### APPEAL SUMMARY

**Appeal ID:** 22150

**Project Address:** 2360 NW Quimby St

**Building/Business Name:** Bodecker Building

Code / Occupancy Plan: **Level 03** **01**

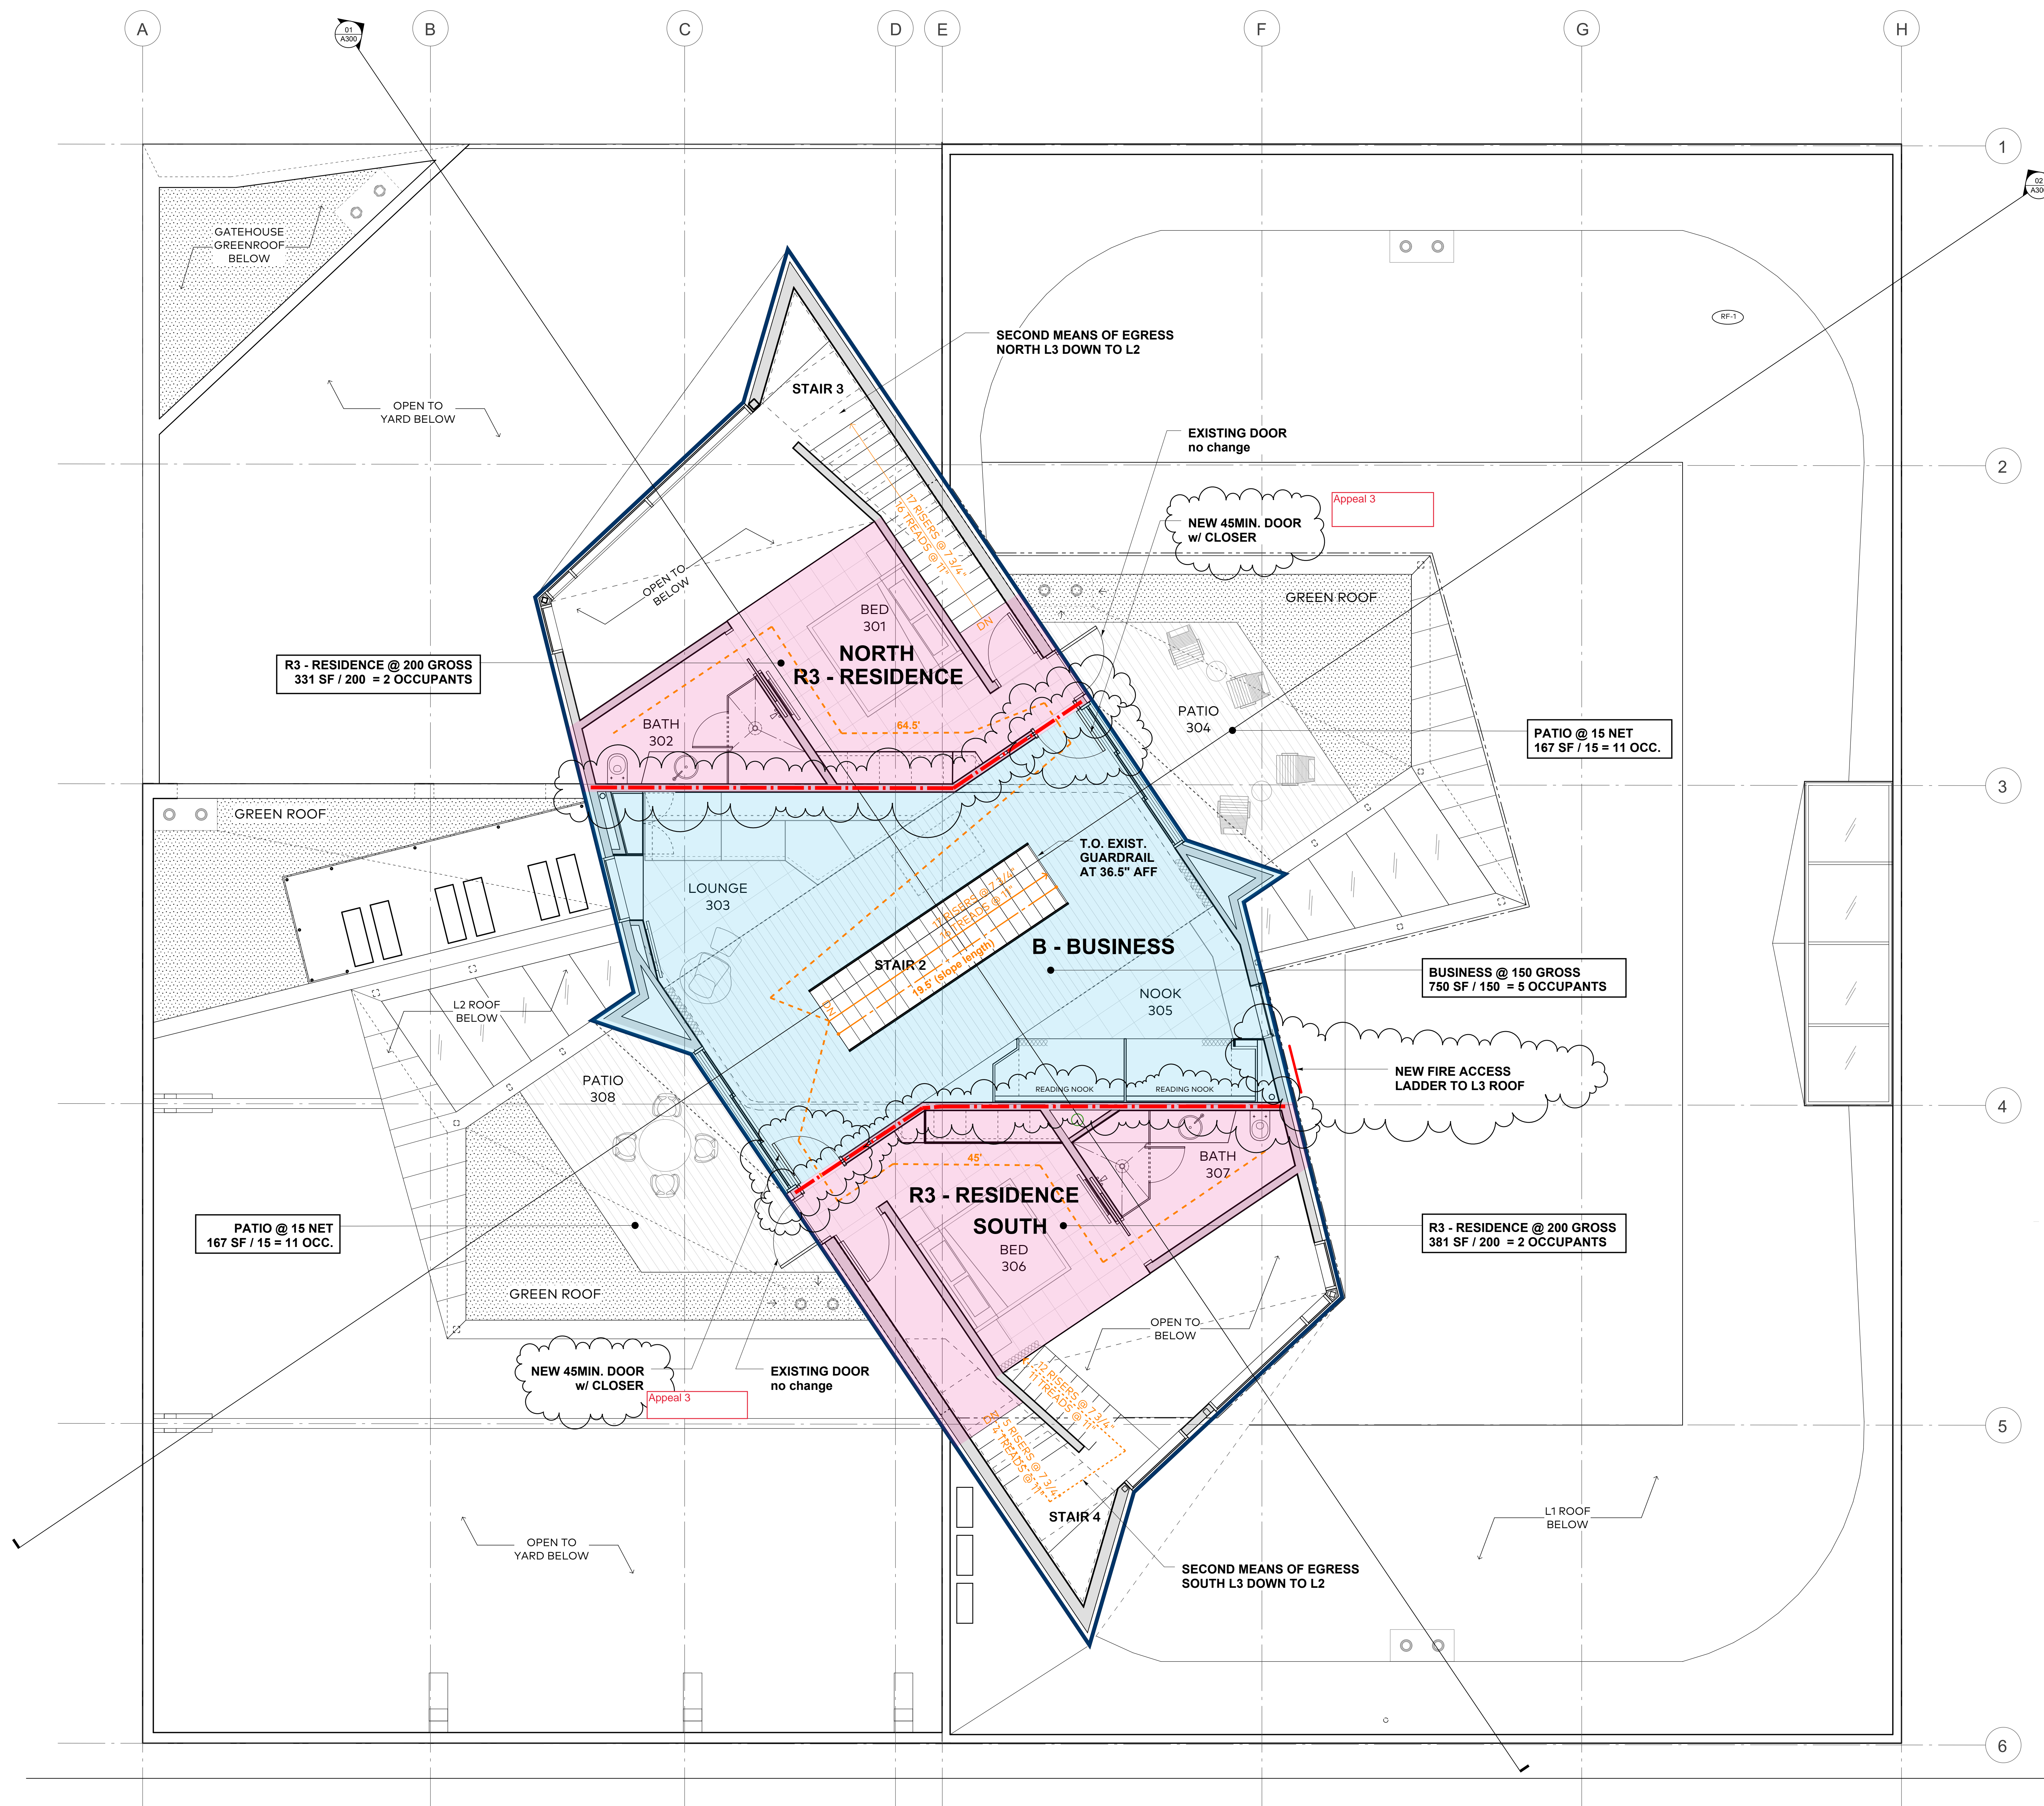
**MAX. COMMON PATH OF TRAVEL: 138'**  
(L3 NORTH UNIT TO L1 STAIR LANDING)

**NEW FIRE SEPARATION PER APPEAL #3**

**2. Increase in maximum common path of egress travel to 138 feet: Denied. Proposal does not provide equivalent Life Safety protection.**

CODE PLANS  
**L1**  
© 2014 SkyLab Architecture. This document is an Instrument of Service and the property of the Architect and may not be duplicated, displayed, or reproduced without the written consent of SkyLab Architecture.

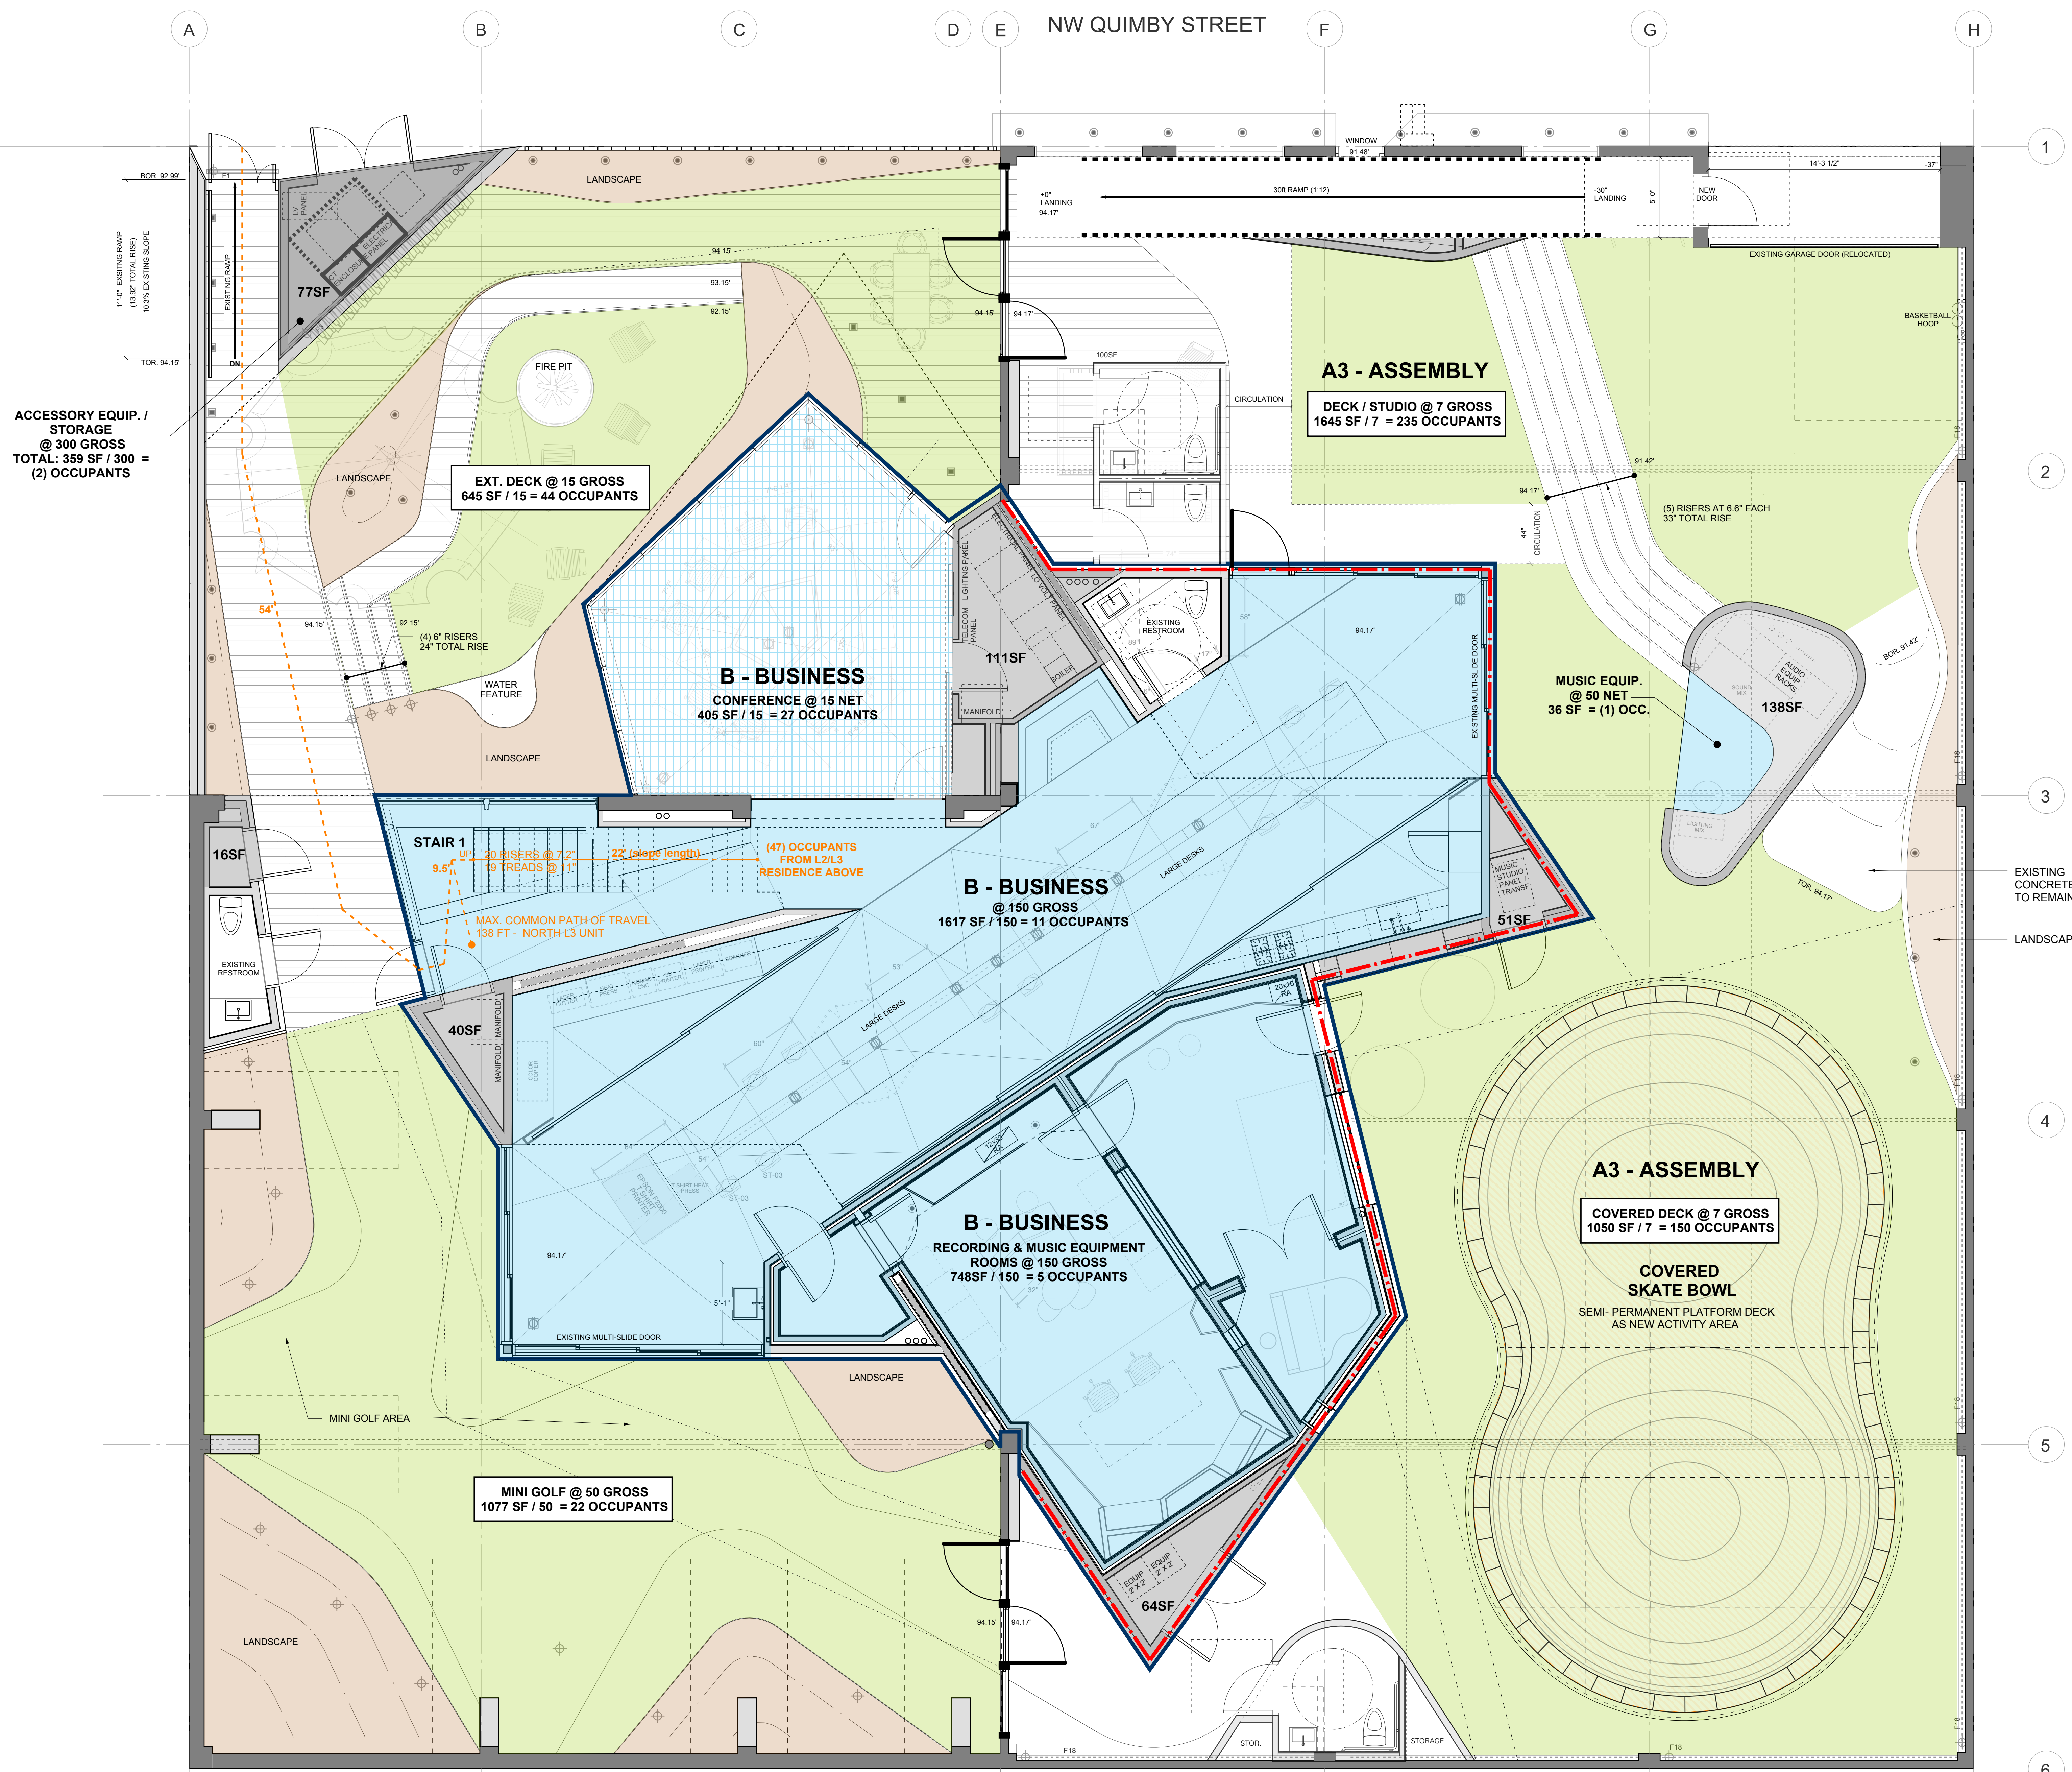
BUILDING OWNER / OPERATOR REQUESTS  
TO DESIGNATE ENTIRE FIRST FLOOR LEVEL  
WITH A **MAX. OCCUPANCY OF 250 PEOPLE.**

THE CALCULATED OCCUPANCIES ABOVE DO  
NOT ACCURATELY REPRESENT HOW THIS  
SPACE IS ACTUALLY INTENDED TO BE USED.

REFERENCE BUILDING CODE APPEAL #8

**7. Reduction in occupant load: Denied. Proposal does not provide equivalent Life Safety protection.**

Building Section: NW/SE 02  
1/4"=1'-0"

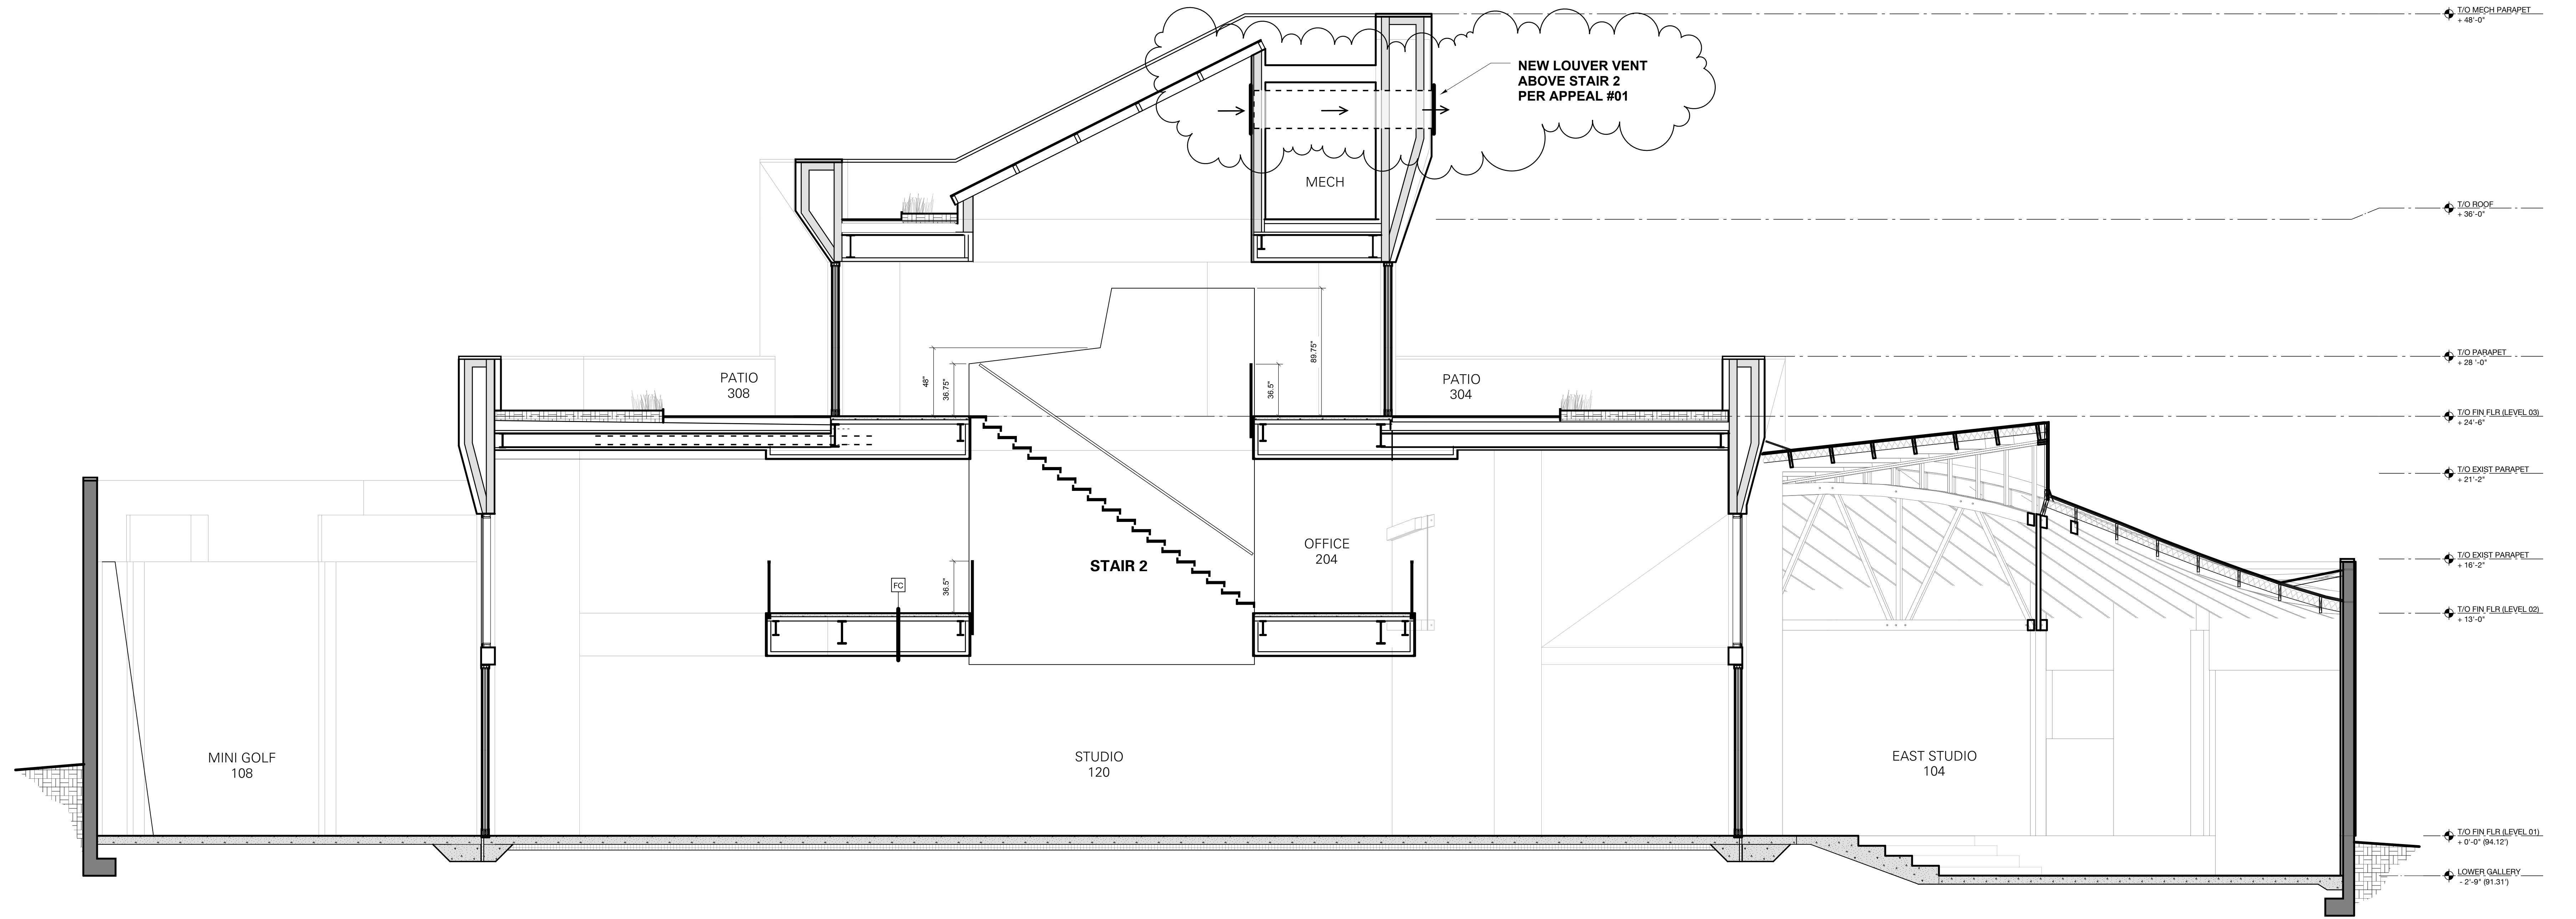
--- NEW FIRE SEPARATION  
PER APPEAL #4

**4. Alternate 1 hour vertical occupancy separation: Denied. Proposal does not provide equivalent Life Safety protection.**
